Access Compliance Report

Public Rights-of-Way

(Curb Ramps)

Intersection ID: 29975	Main Street: DAVID_COX_RD	Cross Street: LEGACY_LAKE_LN	Location: NW
ADA ID: FF1E008EE61B	Ramp Type: Perp	Initial Pass/Fail: Fail	Overall Compliance: No
Severity Score: 21.25			
Codes/Mitigation Info/Possible Solution		Field Measurements/Component Compliance

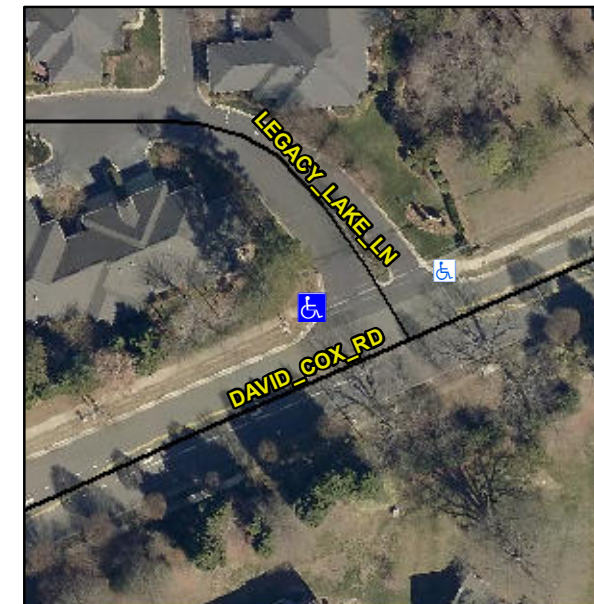
Not Found, R304.5.1, R304.5.3

Compliance	Description	Data	Compliance	Description	Data
N/A	Ramp Length (in)	82.5	Yes	Ramp Slope (%)	5.1
No	Ramp Width (in)	45.5	No	Ramp XSlope (%)	5.4
N/A	Flare Type LT	N/A	N/A	Flare Type RT	N/A
N/A	Flare Slope LT (%)	N/A	N/A	Flare Slope RT (%)	N/A
N/A	Flare Traversable LT?	N/A	N/A	Flare Traversable RT?	N/A
N/A	Landing Length (in)	N/A	N/A	DWS Provided?	N/A
N/A	Landing Width (in)	N/A	N/A	DWS Contrast?	N/A
N/A	Landing Slope (%)	N/A	N/A	DWS Length (in)	N/A
N/A	Landing X Slope (%)	N/A	N/A	DWS Full Width?	N/A
N/A	Landing Curb? (Y/N)	N/A	N/A	DWS Offset (in)	N/A
N/A	Shared Landing?	N/A			
N/A	Gutter Ponding?	N/A	N/A	Gutter Slope (%)	N/A
N/A	Gutter Lip Ht (in)	0.5	N/A	Gutter X Slope (%)	N/A
N/A	Painted X Walk1?	No	N/A	Painted X Walk2?	N/A
	X Walk 1 Direction	To E		X Walk 2 Direction	N/A
N/A	X Walk 1 Width (in)	N/A	N/A	X Walk 2 Width (in)	N/A
	X Walk 1 Slope (%)	1.7		X Walk 2 Slope (%)	N/A
	X Walk 1 X Slope (%)	5.7		X Walk 2 X Slope (%)	N/A

Remove & Replace Entire Ramp.
